K2 Temperature-Compensated PLL Reference Upgrade

Rev. C, April 25, 2003

Schematic

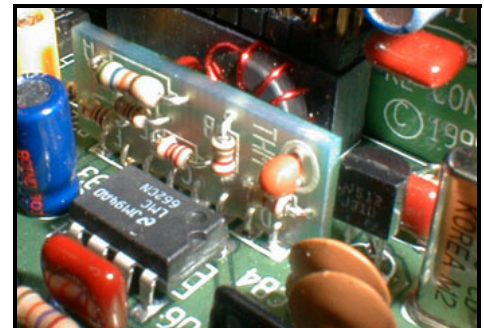
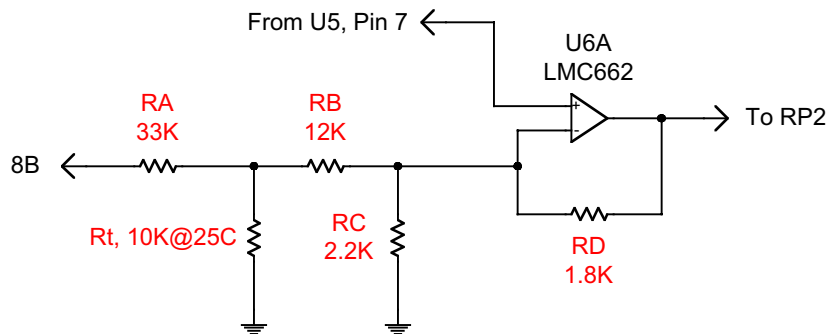
The schematic and a photo of the modifications are shown below. All resistors in combination establish the nominal gain of DC amplifier U6A. The relative values of RA-RD and the thermistor, Rt, set the rate of gain change with temperature. RE and RF (not shown) replace resistors that were contained in RP3 and have no functional effect on the compensation circuit. In the oscillator itself (also not shown), L31 has been changed to 12 μ H, and X1 is a new crystal with improved temperature stability.
